PLANNING BOARD

Tuesday, April 9, 2024 at 4:30 PM
Hybrid Meeting, Room 24 (Ground Floor
of City Hall) and Zoom

To: Chair Brandon Mazer & Members of the Planning Board
From: Eric Freeman
Date: April 5, 2024
Re: 331 Veranda Street
Project ID: PL-002766-2023
CBL: CBL 434 Co01
Meeting Date: April 9, 2024

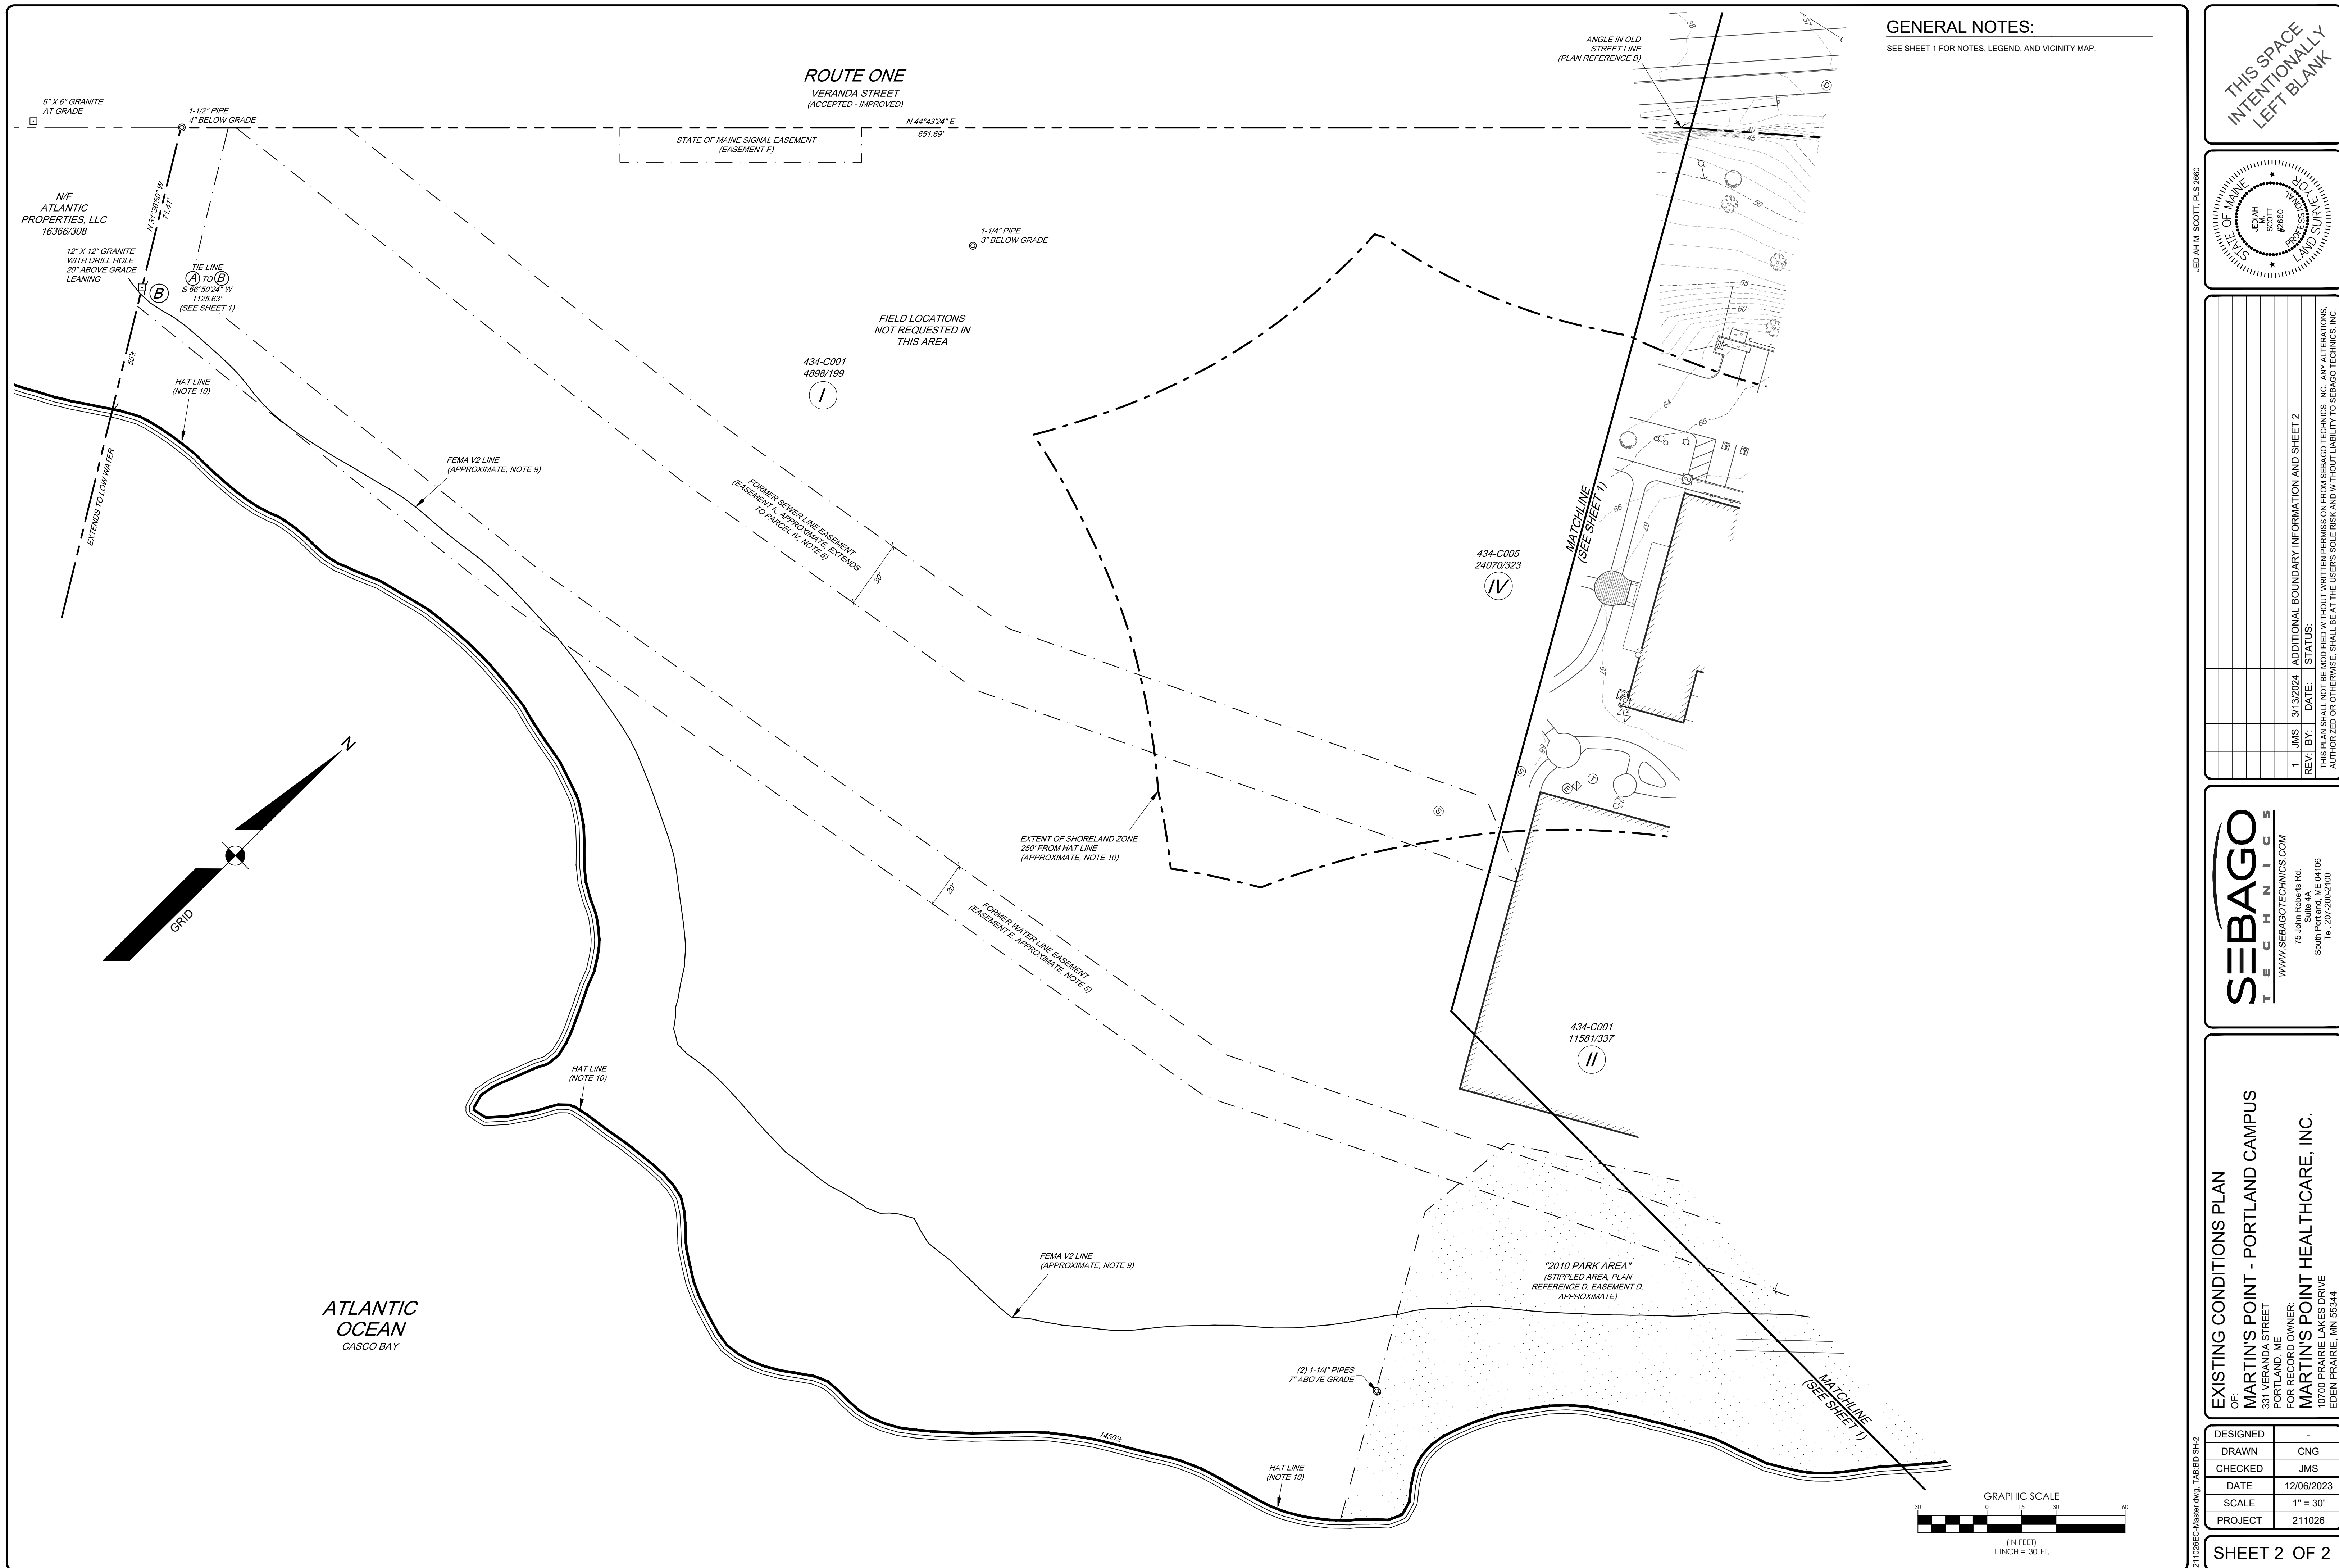
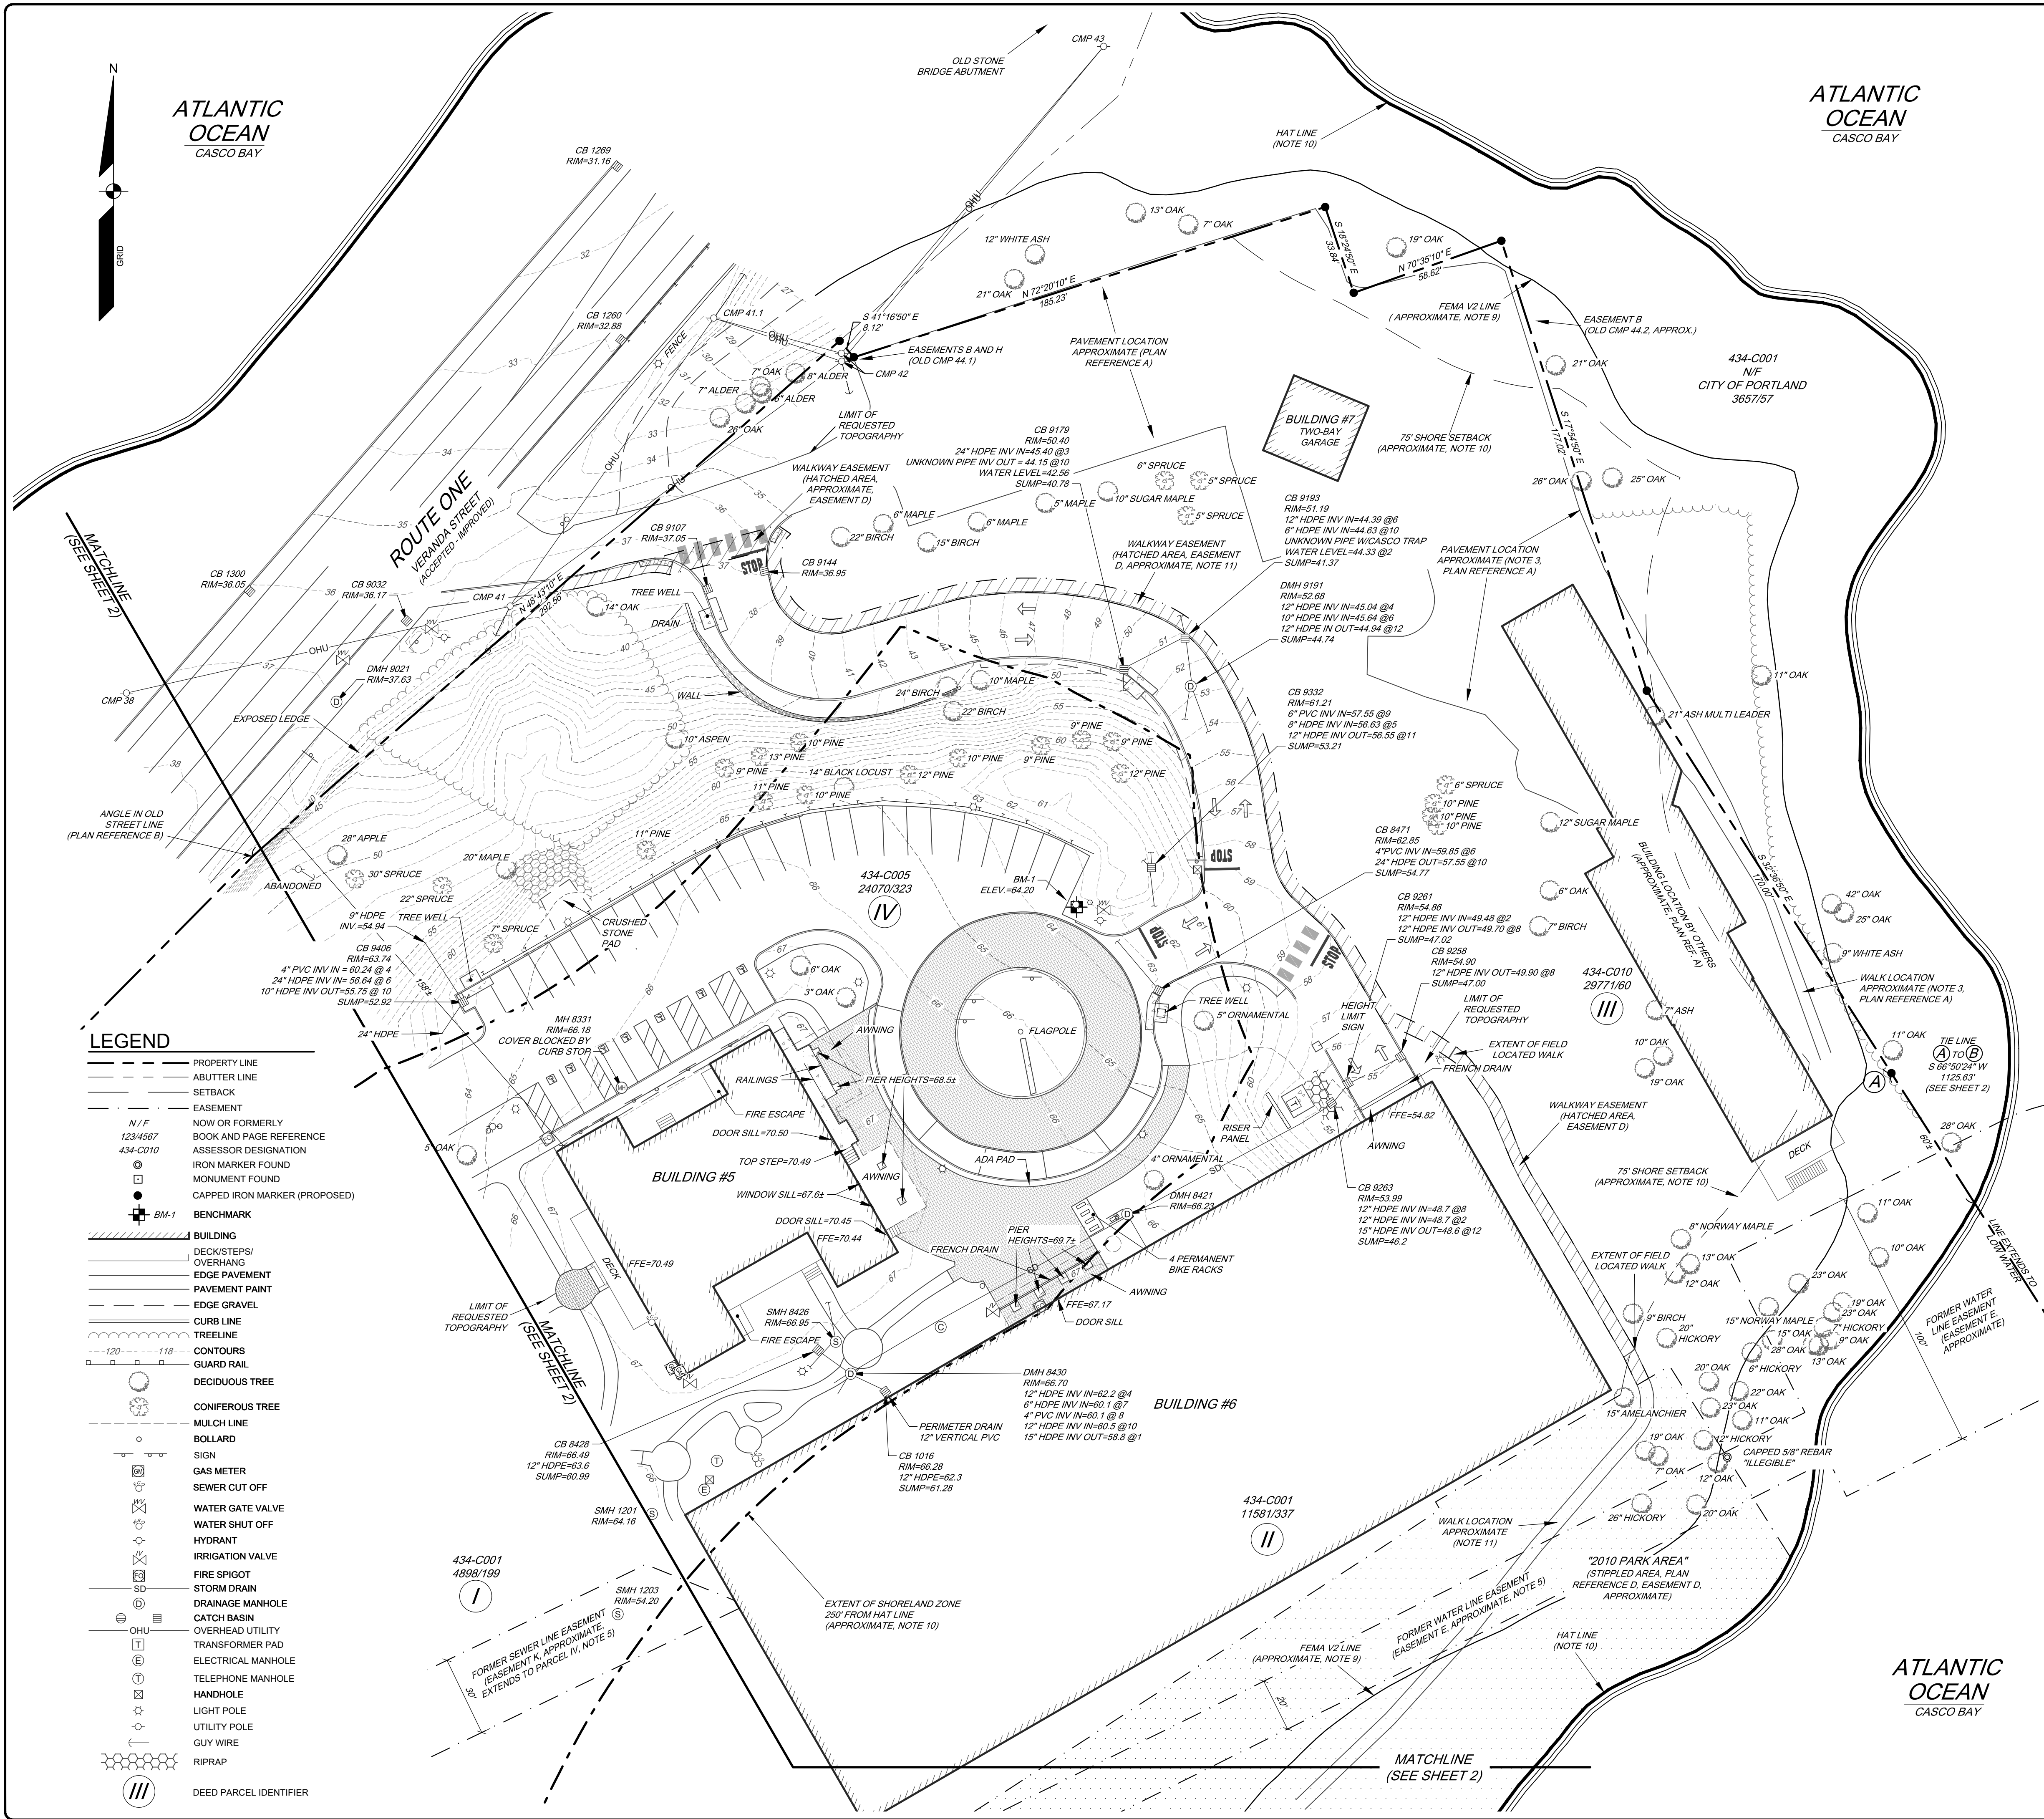
Reference is made to the revised plan *Sheet 40-Tree Preservation and Removal Plan*.

Response: As discussed, Sebago Technics has conducted a point system threshold inventory for trees removed within 75' of the high-water mark as outlined in the referenced City Code above. The results of the inventory are included on plan *Sheet 40-Tree Preservation and Removal Plan*.

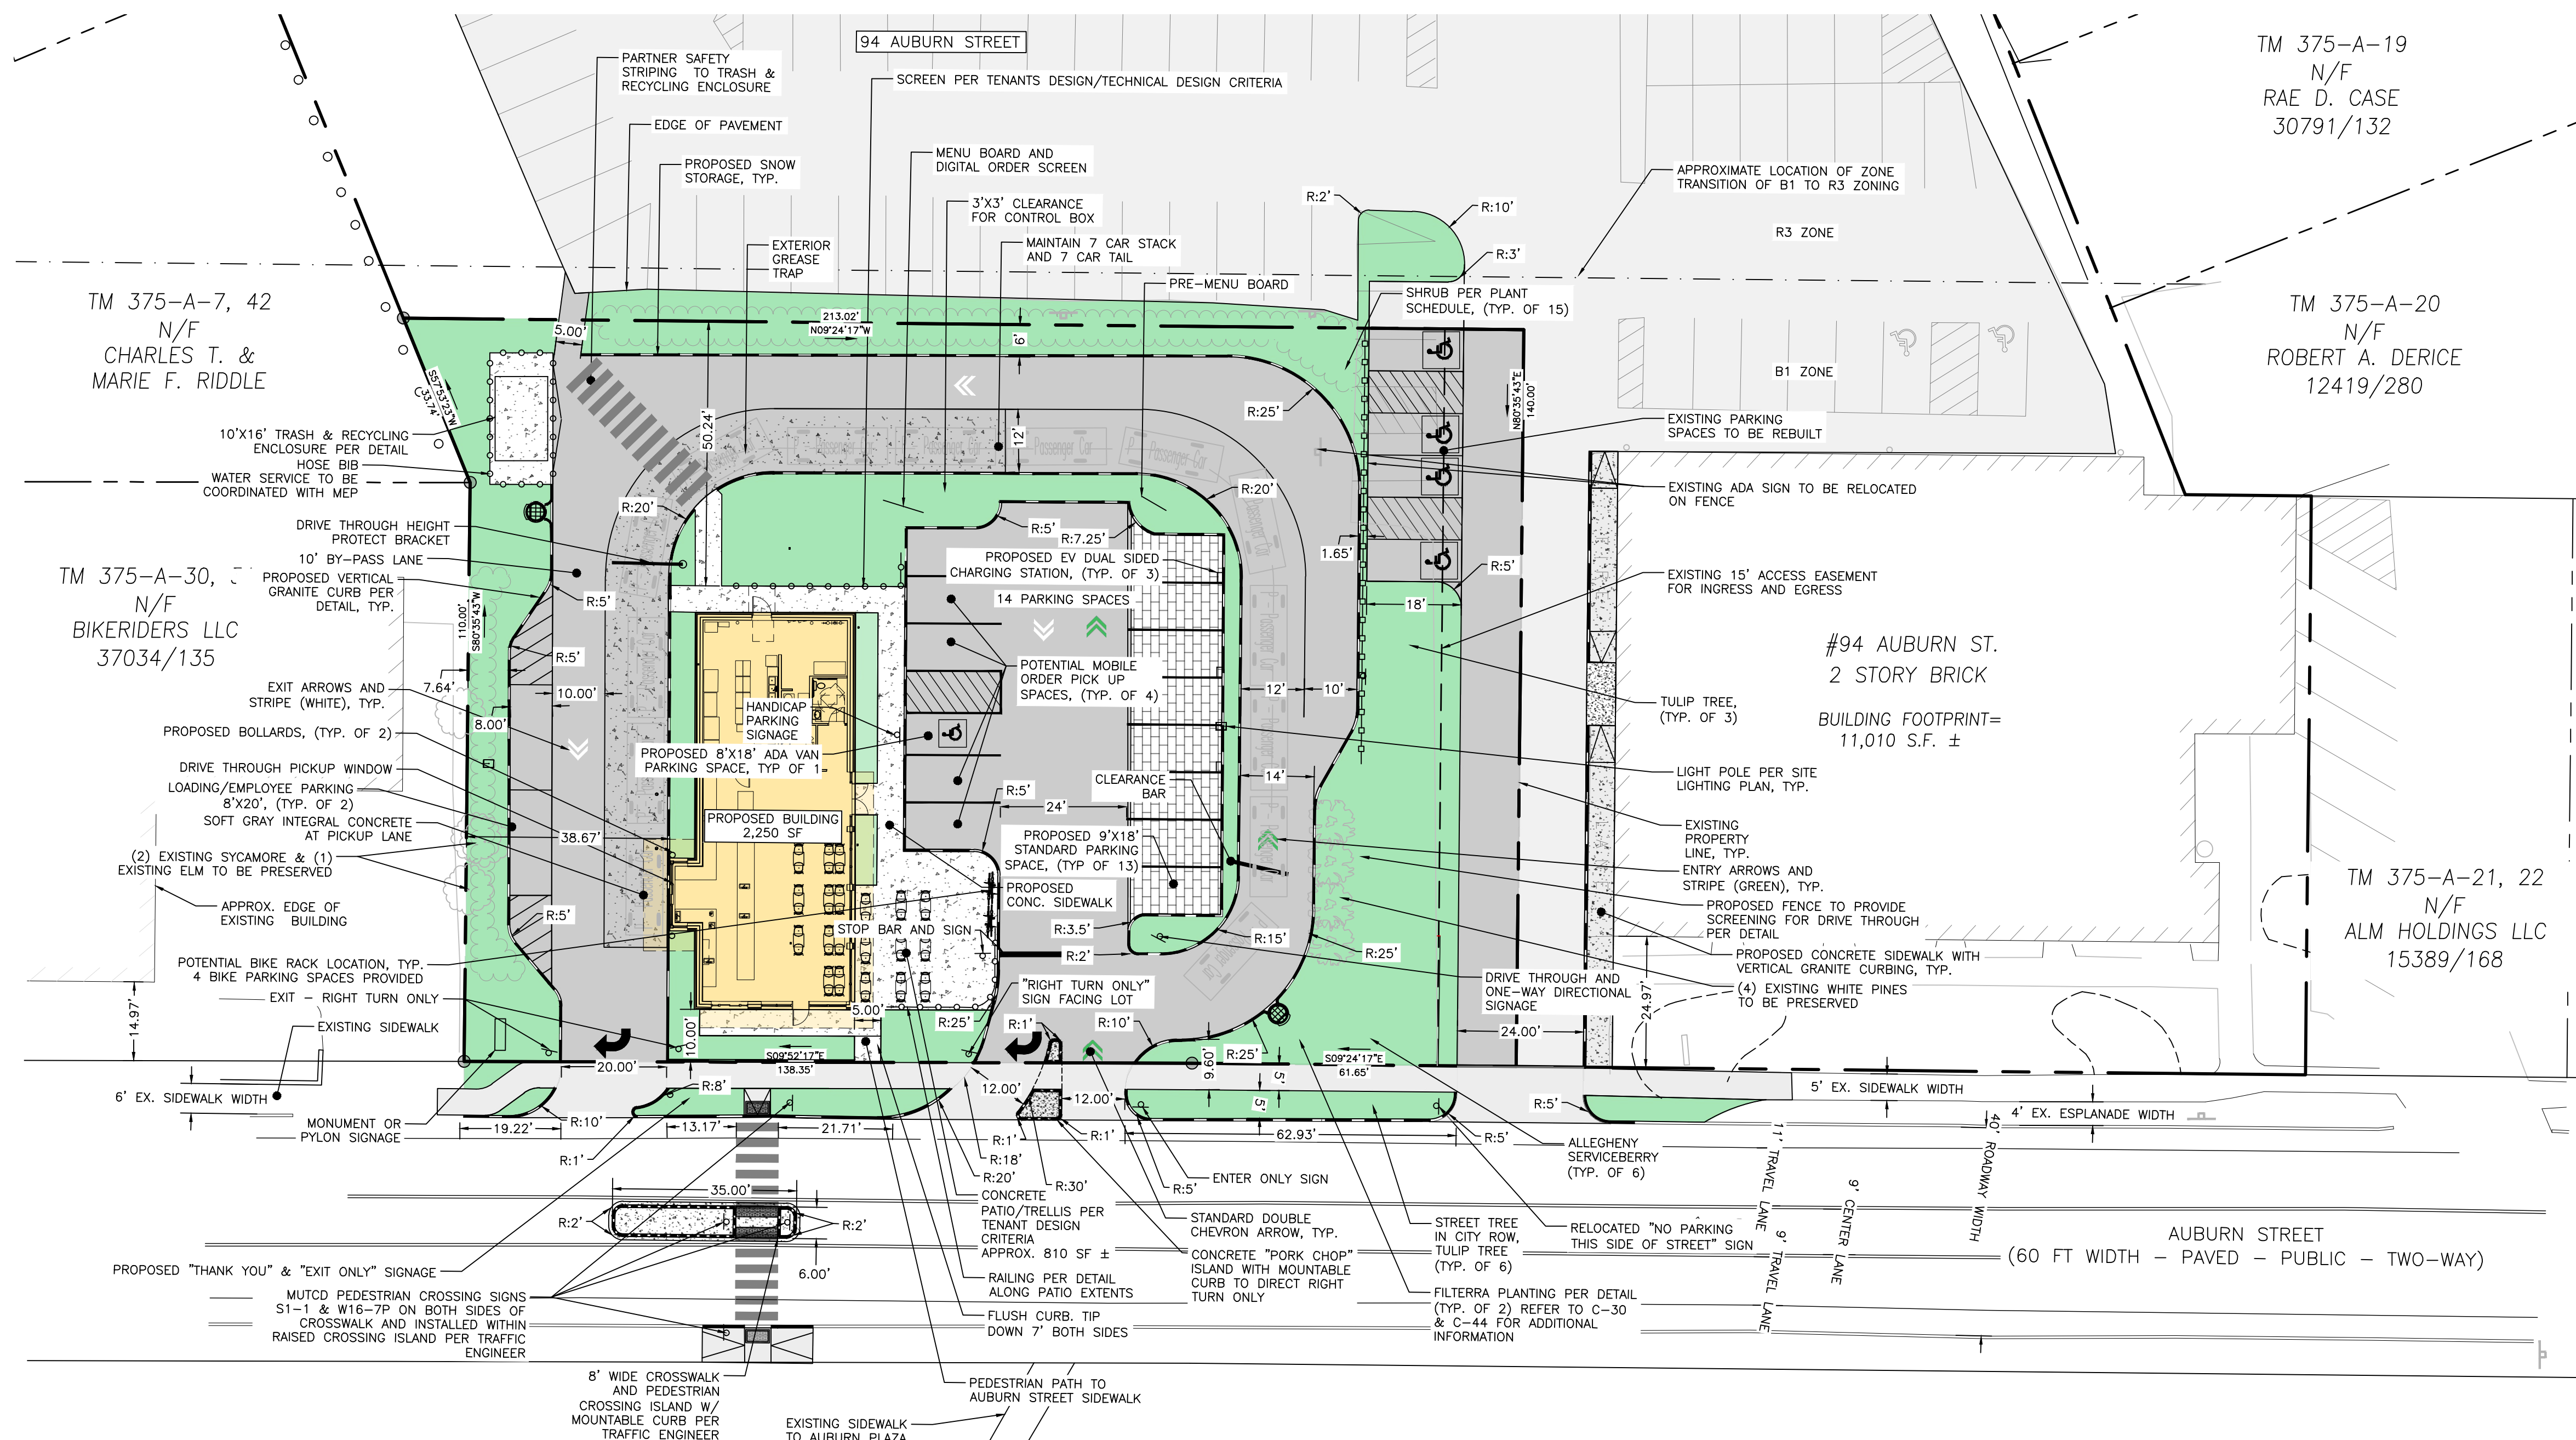
Response – As discussed during the Planning Board Meeting, the existing parking count for 94 Auburn Street will remain the same (with reclassification of existing spaces to additional ADA spaces and associated ADA access aisles). The total proposed number of parking spaces on the 84 Auburn Street parcel will be 16, with a minimum of 15 spaces required by code. With the proposed spaces <10% of the required minimum, no parking study is required, and the waiver table has been updated to remove this waiver request. Please refer to the Parking Summary table on Sheet C-10 Site Plan for additional information.
